**TOWN OF BROOKLYN
Inland Wetlands and Watercourses Commission
Special Meeting Minutes
Virtual Webex Meeting
July 28, 2020**

VERSION 3 ENGINEERING PLAN REVIEW

The comments contained herein pertain to my review of the third version of plans, consisting of eight (8) sheets, entitled "Subdivision Application, 5 Lot Subdivision, Prepared for VBL Properties, LLC, Beecher Road, Brooklyn, Connecticut," prepared by Archer Surveying, LLC and CLA Engineers, Inc., dated June 4, 2020 with revisions as recent as July 8, 2020. Most recent Town of Brooklyn Zoning, Subdivision and Wetlands Regulations and Public Improvement Specifications were researched for this review.

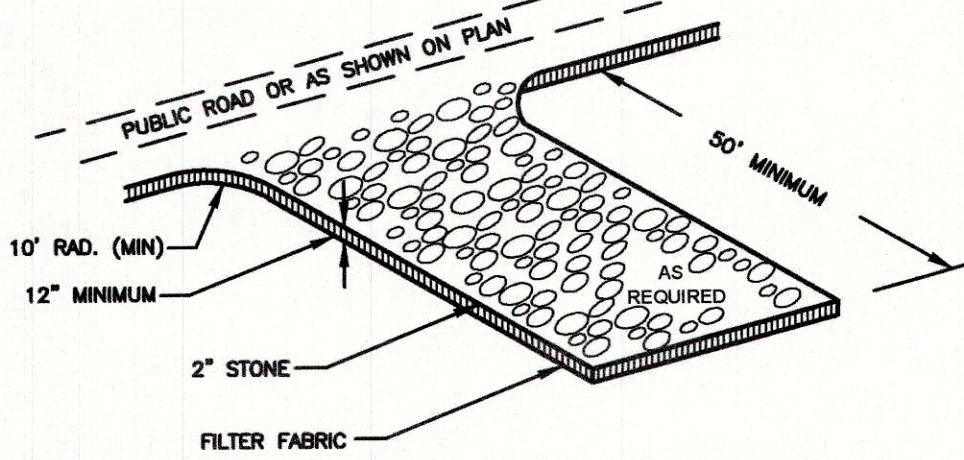
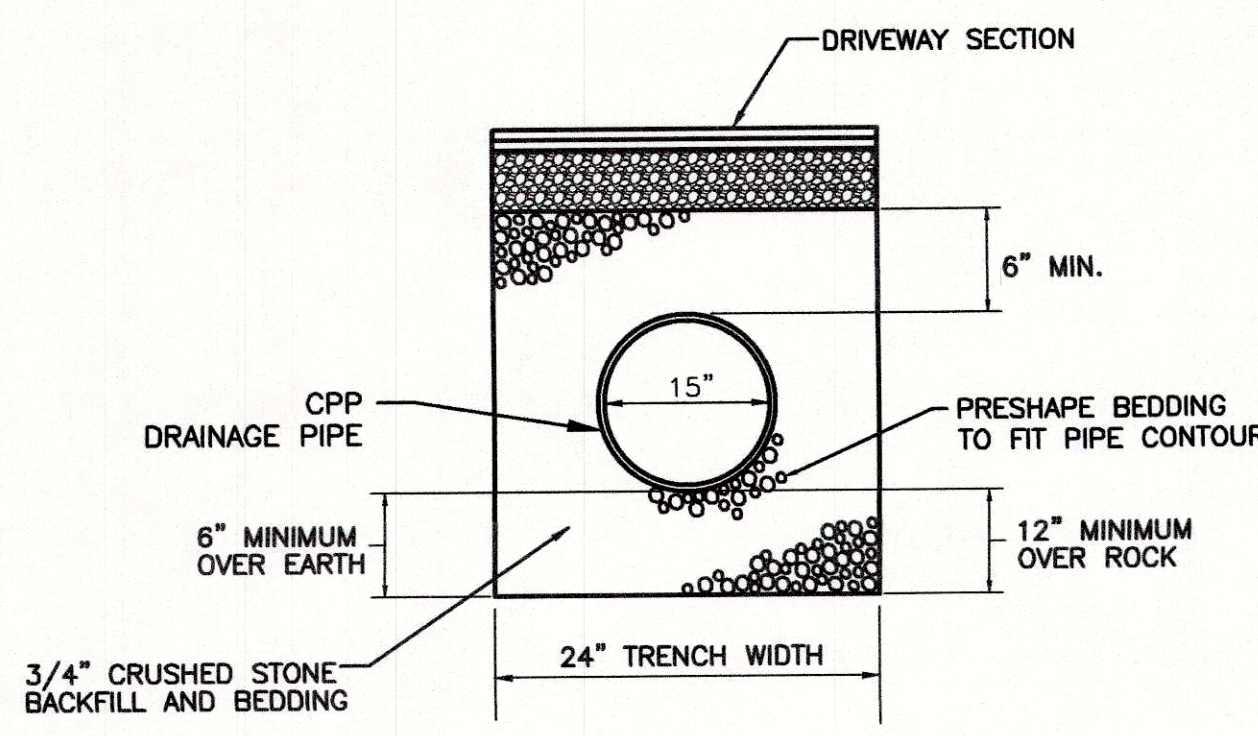
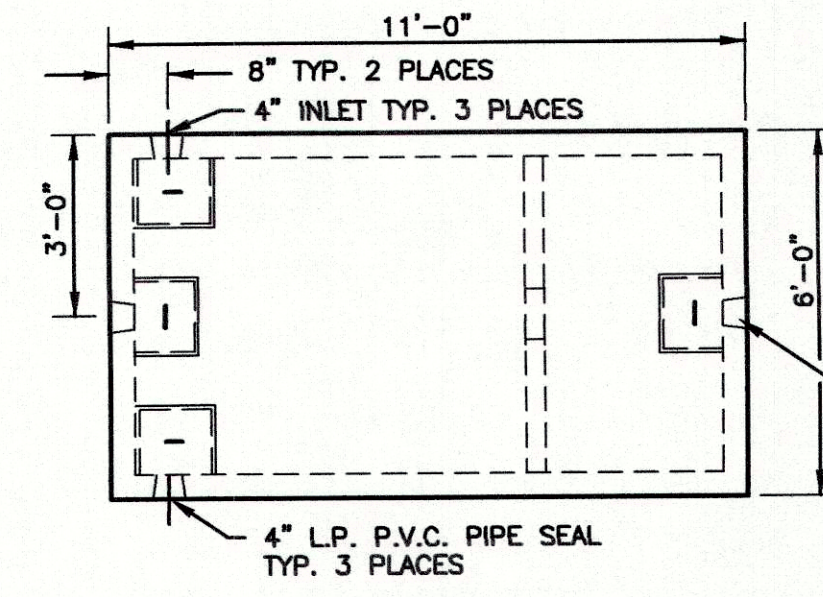
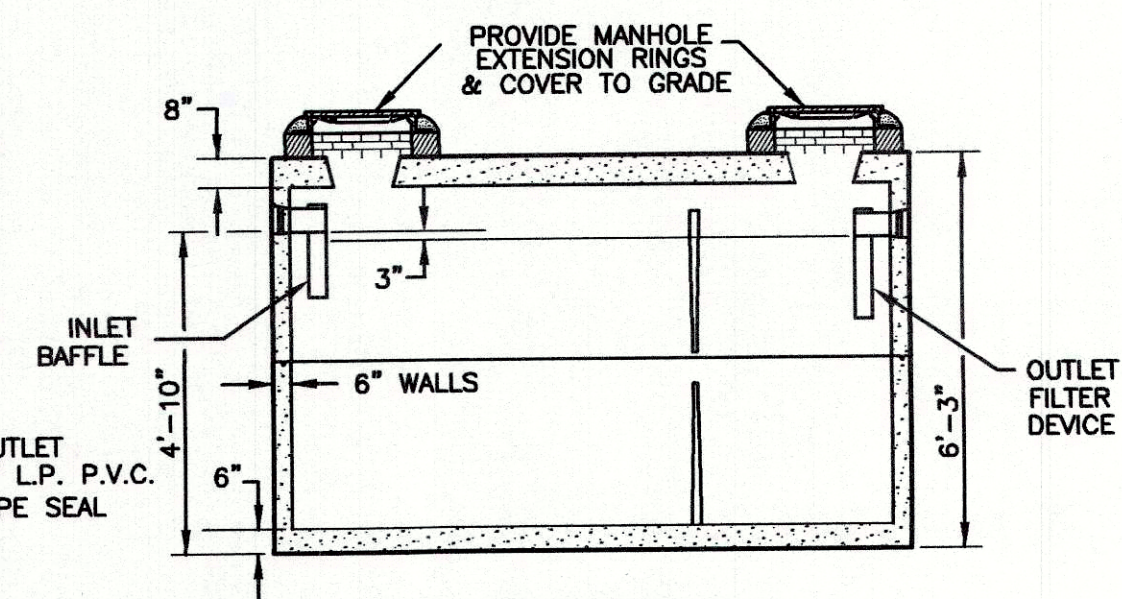
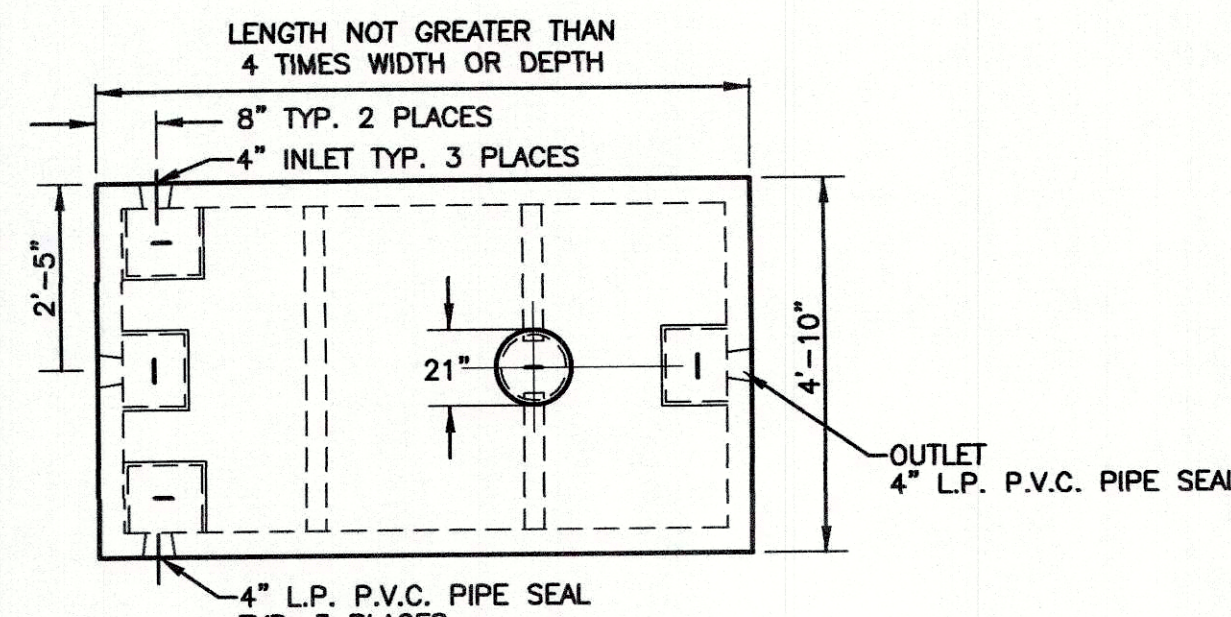
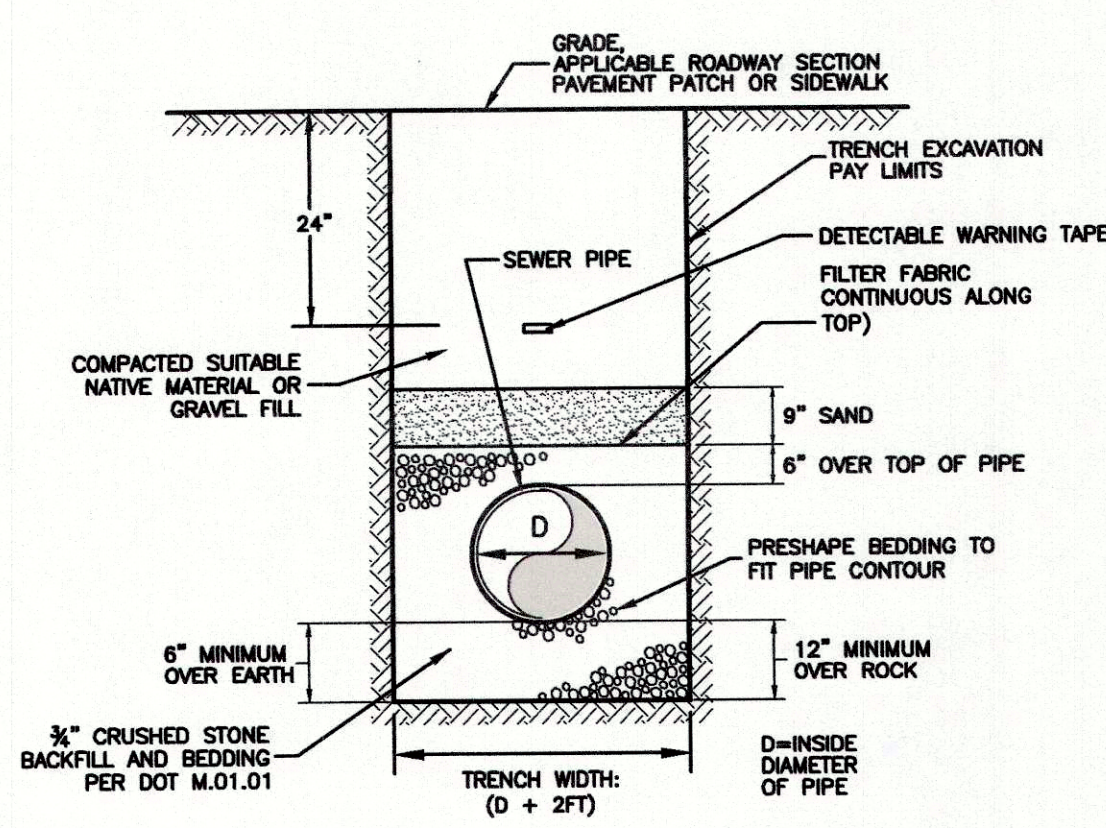
Sheet 7 of 8 – Construction Details

1. A staked hay bale sediment control detail and stone check dam detail should be included on this plan as the use of the same is noted under "Erosion & Sediment Control Narrative" on this plan.
2. In Note No. 9 under the "Erosion & Sediment Control Narrative," it states that slopes steeper than 3H:1V should be constructed with erosion control matting. Slopes steeper than 3H:1V should be avoided to minimize soil erosion and sediment transport due to difficulty in reestablishing and maintaining vegetation on steeper slopes, especially in shady areas. Therefore, it is recommended that no regarded slope exceeds 3H:1V.
3. The professional engineer's seal and signature is missing on this plan.
